# **SARSFIELD ROAD, WILTON**

## DAYLIGHT ASSESSMENT IN RESPONSE TO RFI

11/07/2025

Fig 01. Middle Block floor plan showing increased fenestration and enclosed kitchen (applied to Ground Floor only)

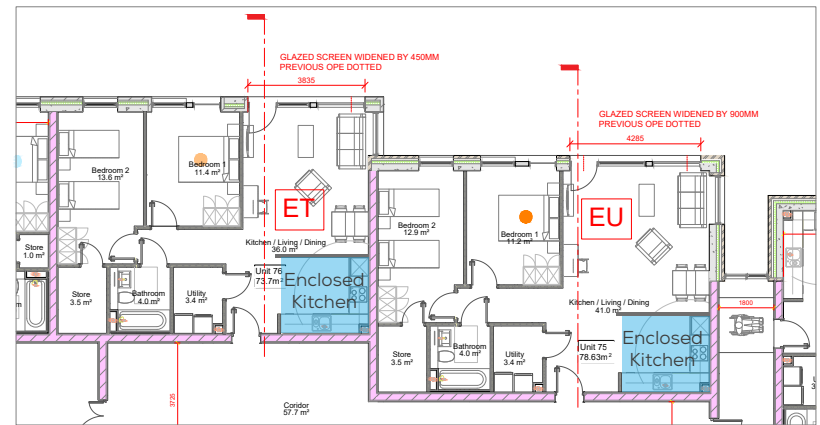
- “The Planning Authority notes that all the apartment blocks are sited in very close proximity to northern boundary of the site, with ground floor single aspect north facing residential units, and notes that some habitable rooms on the ground floor units do not meet the guidance for daylight.
- The Planning Authority has concerns that the provision of a block/solid wall along the northern boundary would have an increased negative impact on residential amenity of future occupants, and result in more units having reduced daylight, and an unsatisfactory residential environment.”

- Middle Block - further increases to the width of the fenestration and separation of the kitchen at the rear of the open-plan LKD with x2 LKDs at Ground Floor. See Fig 01.
- East Block - increases to the width of the fenestration to x9 LKDs, 3 each at Ground, First and Second Floor. See Fig 02.

With the 2.4m high paladin fence, the two LKDs falling short of the recommendation can be improved to meet the recommended level by increasing the width of the window and enclosing the kitchen at the rear as shown earlier in Fig 01. With these amendments incorporated, all north facing habitable rooms would be BRE compliant.

# DAYLIGHT ASSESSMENT RESULTS - WEST BLOCK

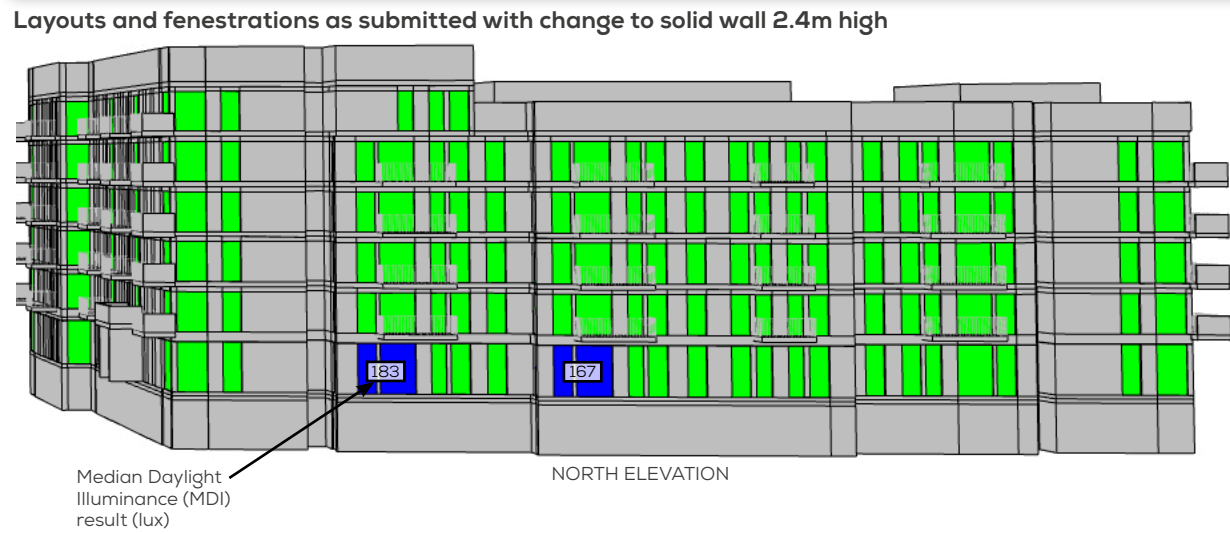
The results show that with a 2.4m high paladin fence, all north facing rooms within the West Block exceed the BRE recommendation for their room use and therefore offer good daylight amenity.

Introduction of a solid 2.4m high wall on the northern boundary in lieu of the more open paladin fence will have a significant impact on daylight to the Ground Floor of the West Block. Whilst most rooms would remain BRE compliant, two open-plan LKDs would reduce from being BRE compliant to meeting the living room target but falling short of the target for rooms with a kitchen.

# DAYLIGHT ASSESSMENT RESULTS - MIDDLE BLOCK

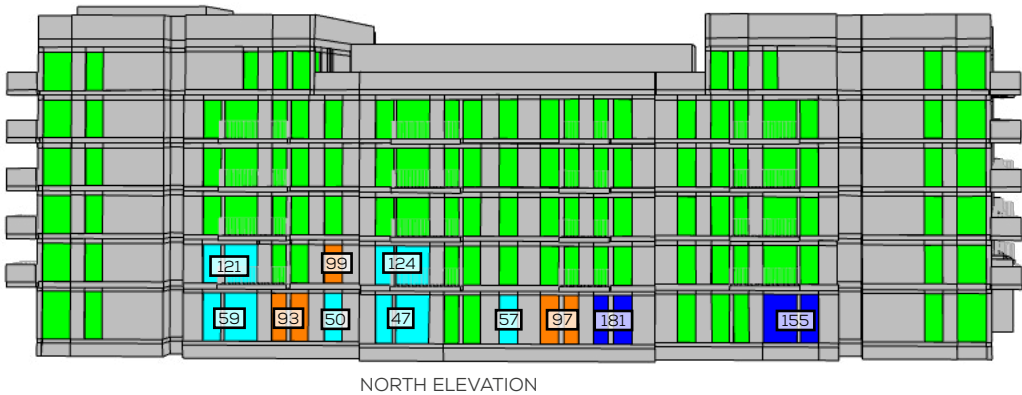
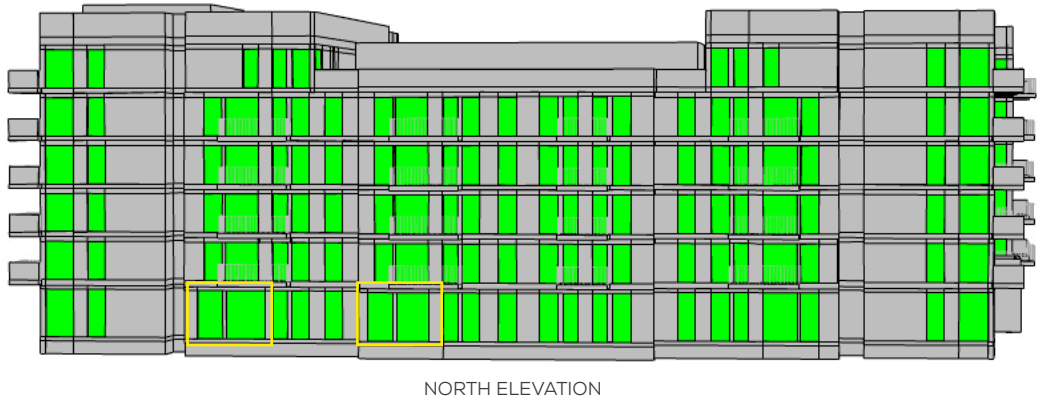
The results show that with a 2.4m high paladin fence, all but two north facing rooms within the Middle Block exceed the BRE recommendation for their room use and therefore offer good daylight amenity. The two remaining rooms, both open-plan LKDs and shown in cyan, fall short of the recommendation.

Introduction of a solid 2.4m high wall on the northern boundary in lieu of the more open paladin fence will have a significant impact on daylight to the Ground and First Floors of the Middle Block. Daylight to the two Ground Floor LKDs already below recommendation would halve and an additional nine rooms (four LKDs and five bedrooms) would fall short of the recommended level.

REVISED.  
ALL NORTH FACING UNITS  
ARE NOW BRE COMPLIANT

# DAYLIGHT ASSESSMENT RESULTS - EAST BLOCK

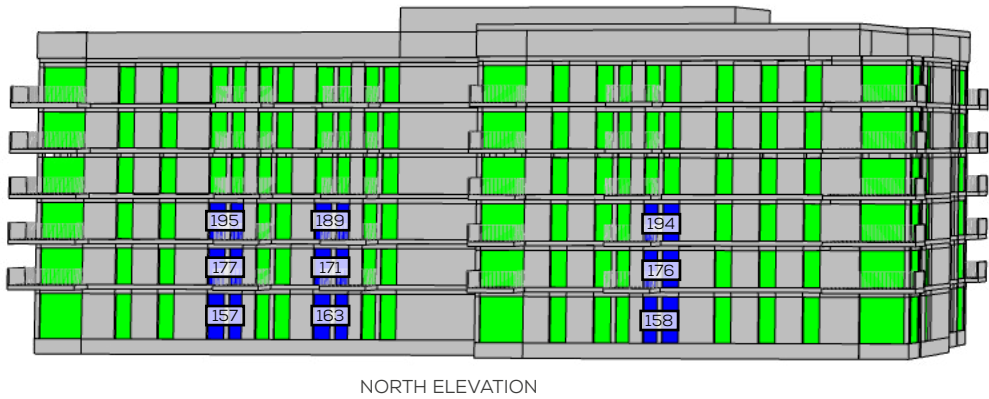
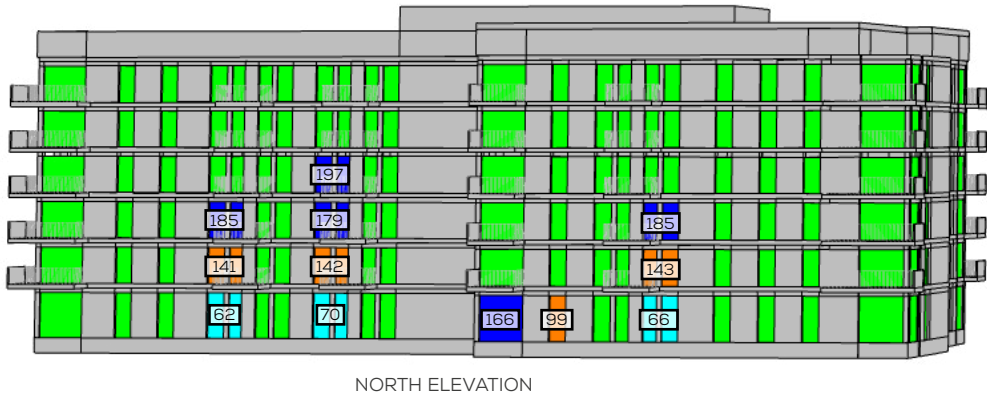
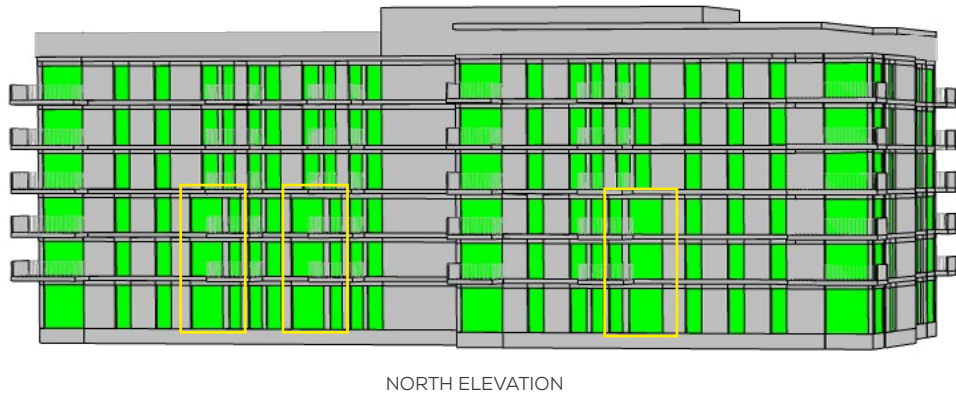
The results show that with a 2.4m high paladin fence, all but nine north facing rooms within the East Block exceed the BRE recommendation for their room use and therefore offer good daylight amenity. The nine remaining rooms, all open-plan LKDs and shown in blue, fall short of the recommendation for rooms with a kitchen of 200lux but would meet the living room recommendation of 150lux so may be considered acceptable for their primary use.

Introduction of a solid 2.4m high wall on the northern boundary in lieu of the more open paladin fence will have a significant impact on daylight to the Ground and First Floor of the East Block. Daylight to the six LKDs already below recommendation for rooms with a kitchen would reduce to less than half their value with the paladin fence at Ground Floor and to marginal failures at First Floor. An additional two rooms (one LKD and on bedroom) would fall short of the recommended level.

REVISED.  
ALL NORTH FACING UNITS  
ARE NOW BRE COMPLIANT

With the 2.4m high paladin fence, the nine LKDs falling short of the recommendation can be improved to meet the recommended level by increasing the width of the windows as shown earlier in Fig 02. With these amendments incorporated, all north facing habitable rooms would be BRE compliant.
